Item Name: Fwd Crosstube - Mid Height 206L / L1 / L3 / L4, Blue

DART AEROSPACE LTD HAWKESBURY, ONTARIO, CANADA	
DRAWING NO. D206-667-147	REV. A SHEET 1 OF 4
TITLE CROSSTUBE ASS'Y (206L MID FWD)	SCALE NTS
COPYRIGHT © 2010 BY DART AEROSPACE LTD THIS DOCUMENT IS PRIVATE AND CONFIDENTIAL AND IS SUPPLIED ON THE EXPRESS CONDITION THAT IT IS NOT TO BE USED FOR ANY PURPOSES OR COPIED OR COMMUNICATED TO ANY OTHER PERSON WITHOUT WRITTEN PERMISSION FROM DART AEROSPACE LTD.

DRAWING NO. D206-667-147	TITLE CROSSTUBE ASS'Y (206L MID FWD)	REV. A	DART AEROSPACE LTD ENGINEERING ORDER		D.E.O. NO. D206-667-147-A-1	SHEET NO. SHEET 1 OF 1	SCALE NTS
DRAWN <i>Q</i>	CHECKED <i>ASS</i>	MFG. APPR. <i>MB</i>	APPROVED <i>MD</i>		DE APPR. <i>MB</i>		
DATE 11.07.15	DATE 11.07.20	DATE 11.07.21	DATE 11/07/21		DATE 11.07.21

DRAWING NO. D206-667-147		TITLE CROSSTUBE ASS'Y (206L MID FWD)		REV. A		DART AEROSPACE LTD ENGINEERING ORDER		D.E.O. NO. D206-667-147-A-2		SHEET NO. SHEET 1 OF 1		SCALE NTS	
DRAWN AJS		CHECKED		MFG. APPR.		APPROVED		DE APPR.					
DATE 12.08.02		DATE 12.08.02		DATE 12.08.02		DATE 12.08.02		DATE 12.08.02		DATE 12.08.02

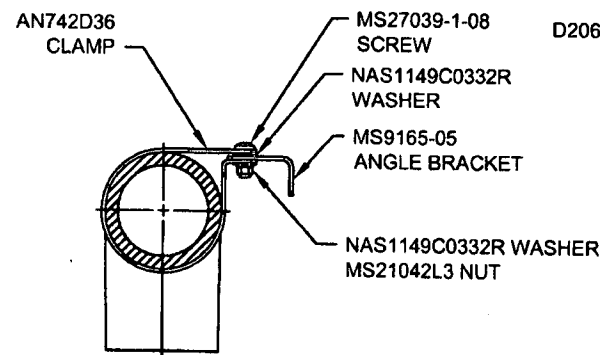
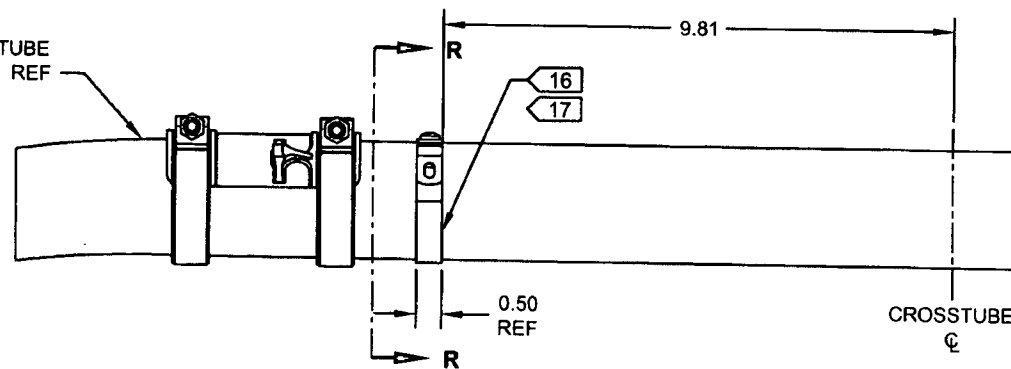
ADD ELECTRICAL GROUNDING STRAP

- 16) MASK AREA UNDER CLAMP PRIOR TO PAINTING
- 17) SEAL EDGES WHERE AN742D36 CLAMP MEETS WITH THE CROSSTUBE USING SIKAFLEX-241/-291 OR MIL-S-8802 CLASS B2 OR PROSEAL 890 SEALANT
- 18) PERFORM RESISTANCE CHECK TO ENSURE MAX RESISTANCE IS 10 MILLIOHMS
